Technical Memorandum

Date:	February 22, 2022	Project No.: 300038790.0000			
Project Name:	South Innisfil Creek Drain - Proposed 2022 Improvements				
Client Name:	Town of Innisfil				
Submitted To:	Mr. Jeremy Nyenhuis, P.Eng., Drainage Superintendent				
Submitted By:	Tim Koen, P.Eng.				
Reviewed By:	Jeff Dickson, P.Eng.

Figure 1 - SICD Construction Phasing Plans

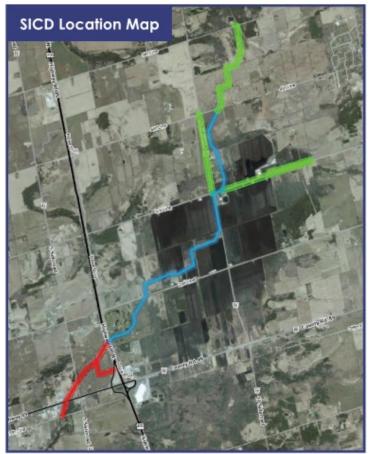
Figure 1 – SICD Construction Phasing Plans is on page 3 of this Memo. The left-hand SICD Location Map with the heading 2021 illustrates the original Phased construction schedule for the proposed improvements to the SICD. The right-hand SICD Location Map with the heading 2022 again shows the various Phases; however, they have been REVISED.

As illustrated in Figure 1, Phase II shown in Green in both the 2021 and 2022 views was scheduled for completion from November 2021 to November 2022. However, and further to Section 2.2, changes are now required in an effort to defer work previously proposed in the "head pond area" until after the completion of the interim drainage solution within the Highway 400 right-of-way. Further, it is also the desire of the Town (and presumably the watershed community) to not delay (unless absolutely necessary) the continuation of the implementation and construction of this multi-phased SICD Improvement project.

To that end, Phase II shown in Green in the 2021 view was contingent on the design, installation, and completion of the Highway 400 interim drainage solution culvert crossings in order to proceed. In the 2022 view, you will notice that it has been switched with Phase III shown in Blue. Additionally, the portion of the Main Drain between 3rd Line and 4th Line has also become part of Phase III.

In Figure 1, Phase III was shown in Blue in both the 2021 and 2022 views; however, its location in the 2022 right hand view has been changed to reflect the proposed changes identified in Section 2.3 and which are now part of Phase II; the works in this phase are proposed to be completed from November 2022 to November 2023.

Accordingly, the sections of the SICD that form the new Phase II as shown in Green are being proposed for construction from November 2021 to November 2022. Specifically, these sections of the SICD include the following:

- a) The SICD Main Drain upstream from 4th Line to the 5th Line including the replacement of the crossing under 4th Line;
- b) The 10 Sideroad Branch Drain including replacing the crossing under 3rd Line;
- c) The 3rd Line Branch Drain; and
- d) The 3rd Line Spur Branch Drain.

Phase III of the SICD project will include the proposed deepening, widening and improvement work on the Main Drain from the Reive Boulevard right-of-way upstream to the south side of the 4th Line culvert crossing scheduled to be completed as part of Phase II in 2022.
